VTech Telecommunications Ltd

Request for Class II Permissive Change

FCC ID: EW780-1922-00

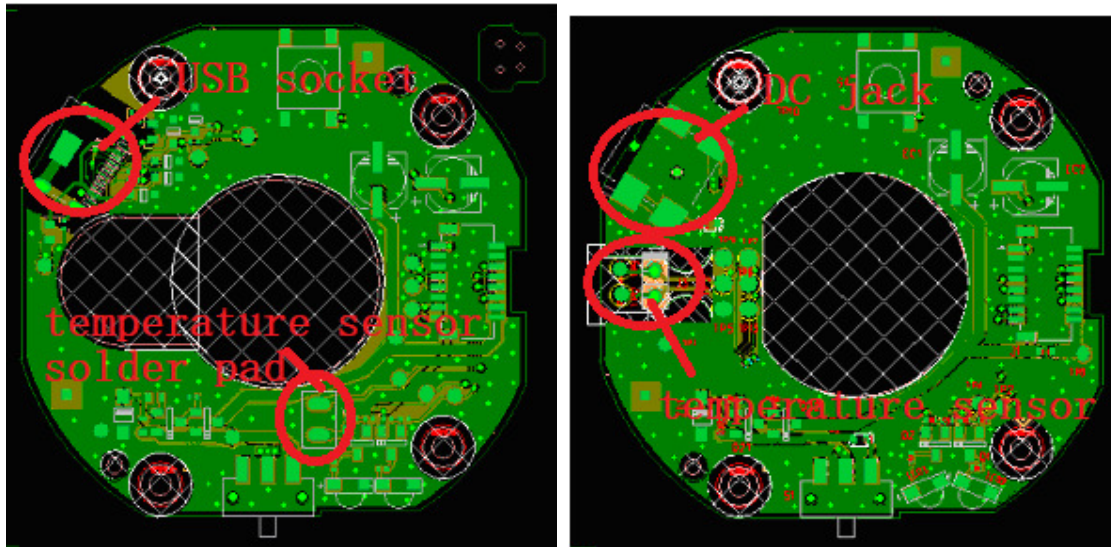
Changes of Baby Unit from reference model to the new designed model:

- **External appearance is slightly changed**
- **Power PCB changed from USB type C to DC jack**
- **Temperature sensor changed from external to internal**
- **VTPL adaptor VT05EUS05100 change from type C to DC jack**
- **remove adaptor Ten Pao S005CAU0500100**

According to the changes above, no impact on RF circuit and design, and just partial sensor interface was change and then C2PC was requested in this application.
